NSD-NRC-97-5122
DCP/NRC0862
Docket No.: STN-52-003

SUBJECT: REVISED AP600 DESIGN RELIABILITY ASSURANCE PROGRAM LIST OF RISK SIGNIFICANT STRUCTURES, SYSTEMS, AND COMPONENTS

SSAR 16.2 Markup

**(attachment to
NSD-NRC-97-5122)**

Figure 16.2-1

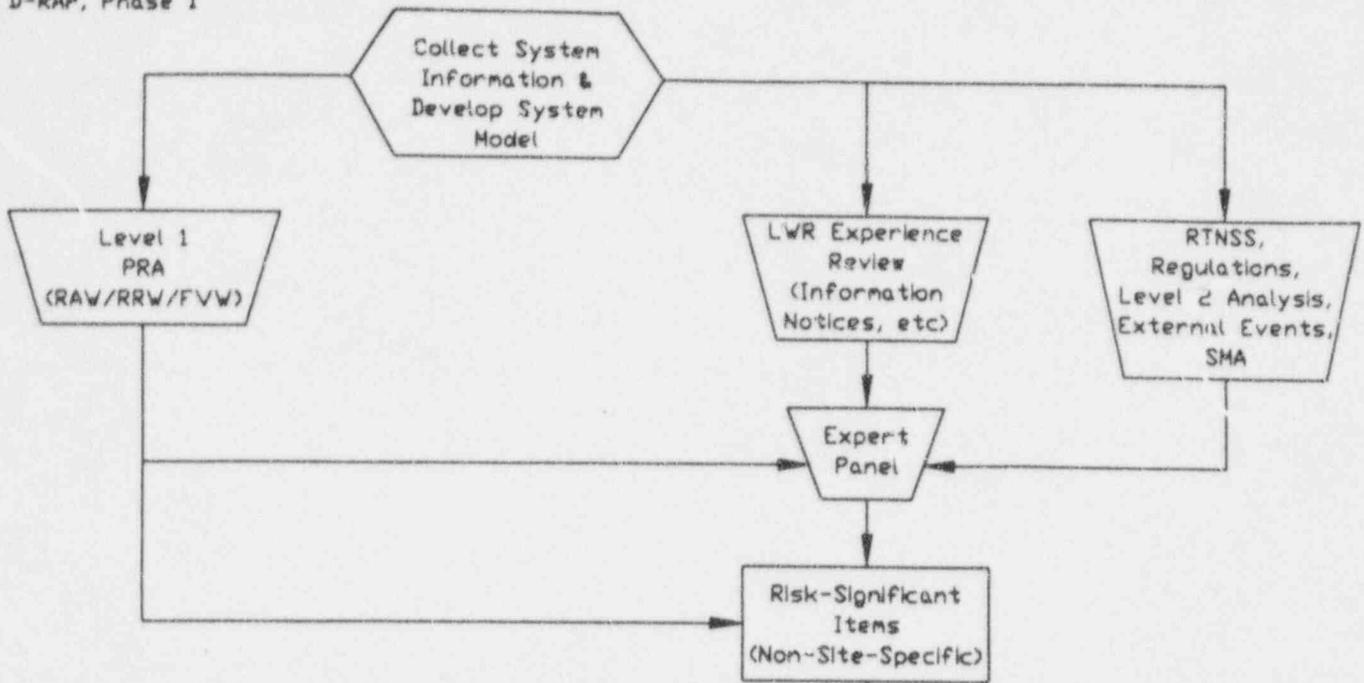
Delete

revised figure
